CITY OF VANCOUVER

POLICY REPORT DEVELOPMENT AND BUILDING

SUBJECT: CD-1 Rezoning - 4887 Cambie Street

Title Elevations	
Scale 1:200	Drawing number 07
Issue date June 19, 2006

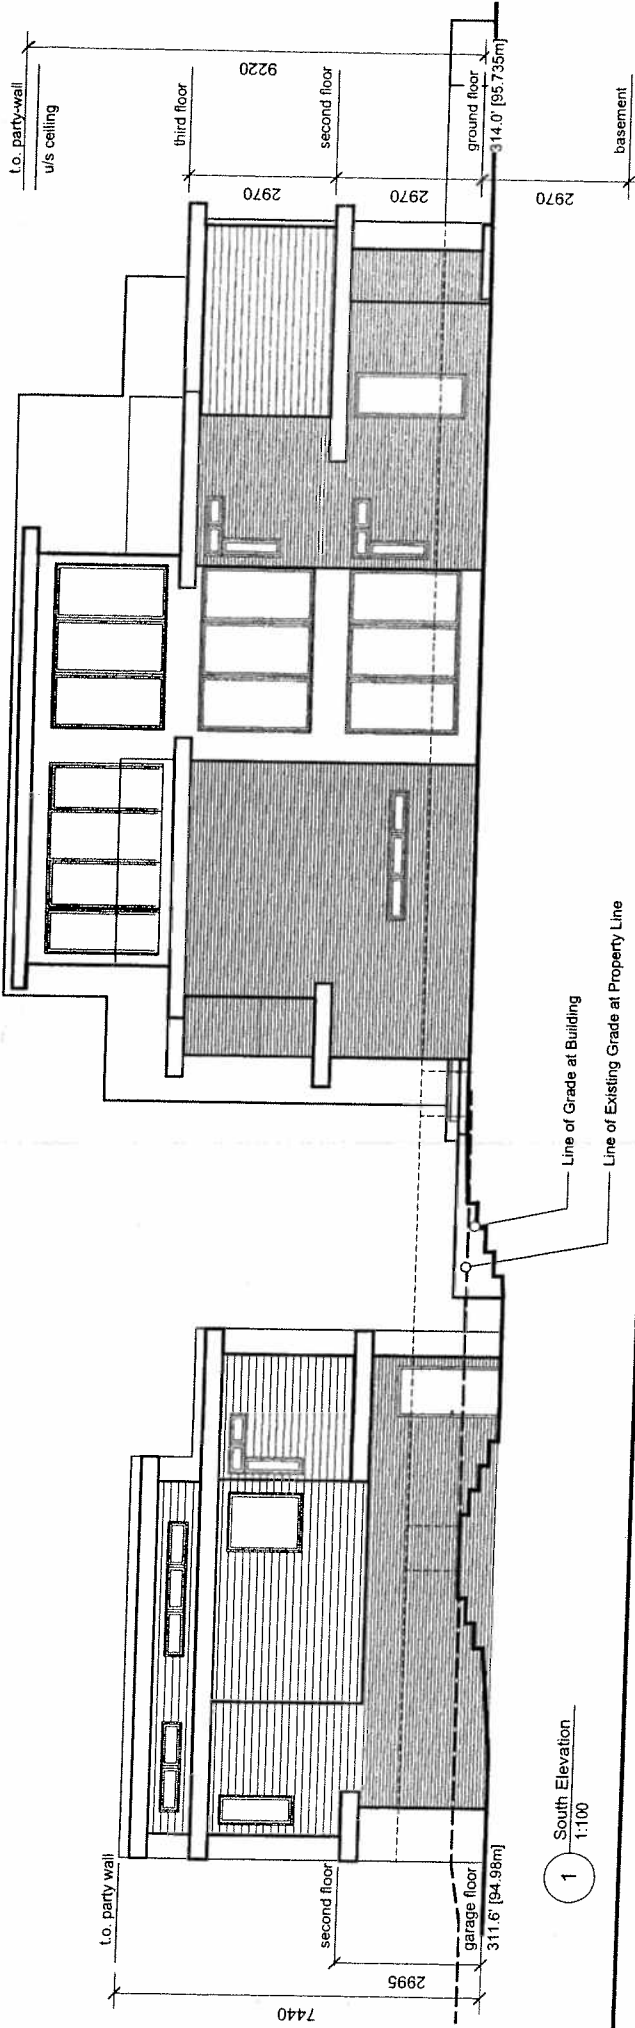
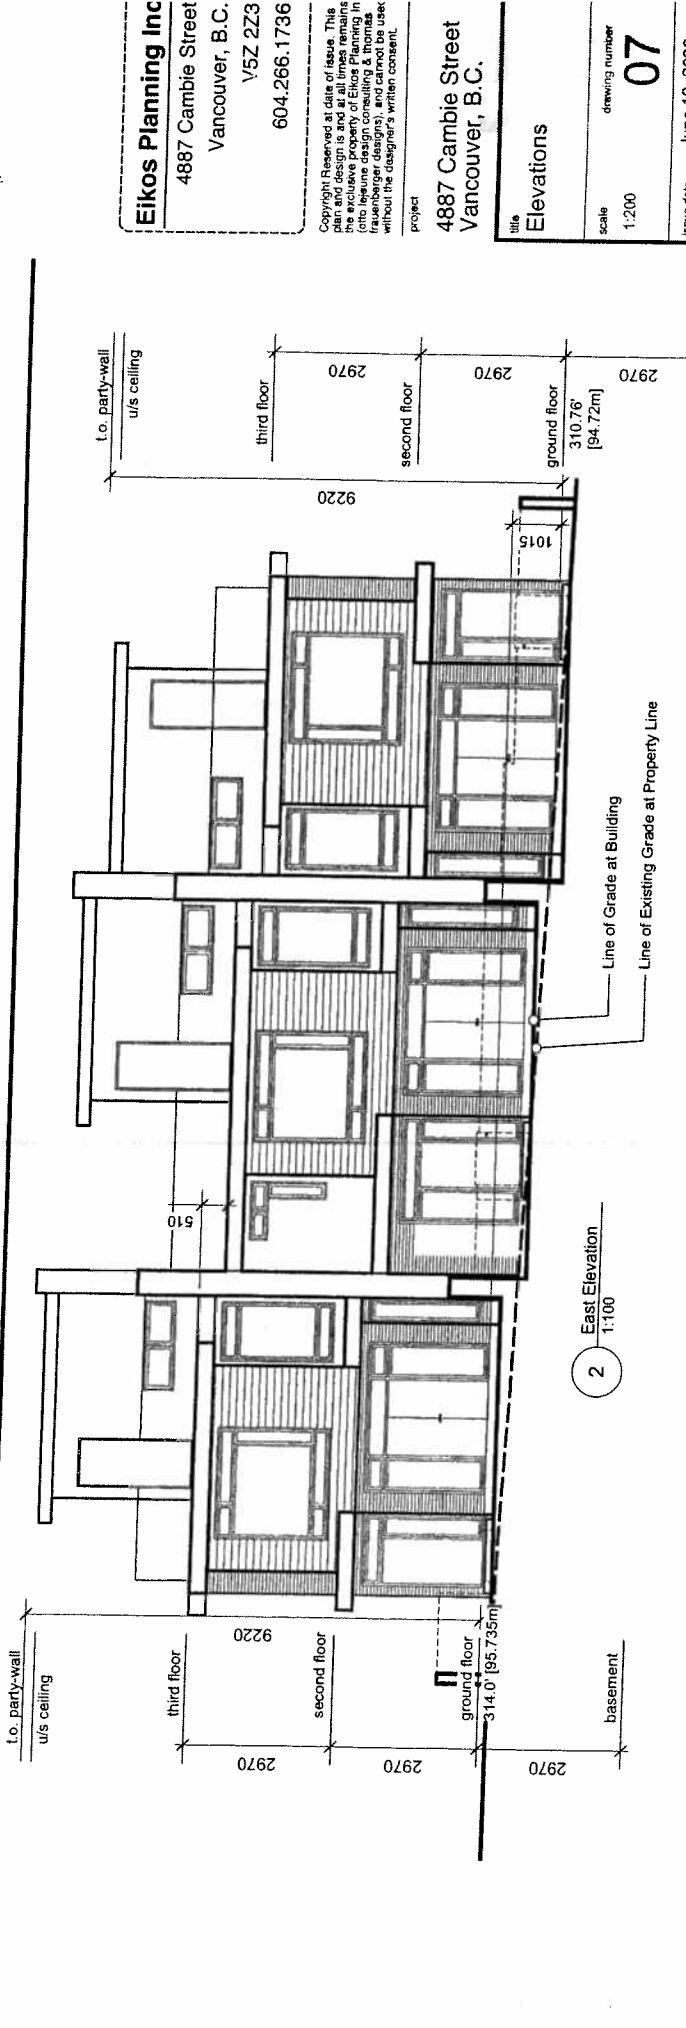
- (i) design development to reduce the height of the building to a maximum height of 9.2 m (30.18 ft.);

- (iii) design development to improve privacy between neighbours, reducing overlook between the proposal and the northerly property;

- increase the front yard setback of the northerly principal dwelling unit by approximately 4 feet;
- reduce the number and area of clear glazed windows facing the interior side yard and orient windows away from the interior side yard, where possible, by stepping of the building massing and through bay projections;

Some members also felt the project was designed to respond to Cambie Street but did not respond well to the 33rd Avenue frontage. The north and south elevations are identical, yet one is an interior lot side elevation and the other is a south facing street frontage.

The Panel was concerned about the emphasis of the fire/party wall feature and felt they could be better integrated into the design so as not to be so strongly emphasized in the architectural expression. The extension of these walls as balcony privacy screens was seen as excessive. The penthouse top floor elements on the street front units could be better integrated into the building form so as not to appear as add-ons.
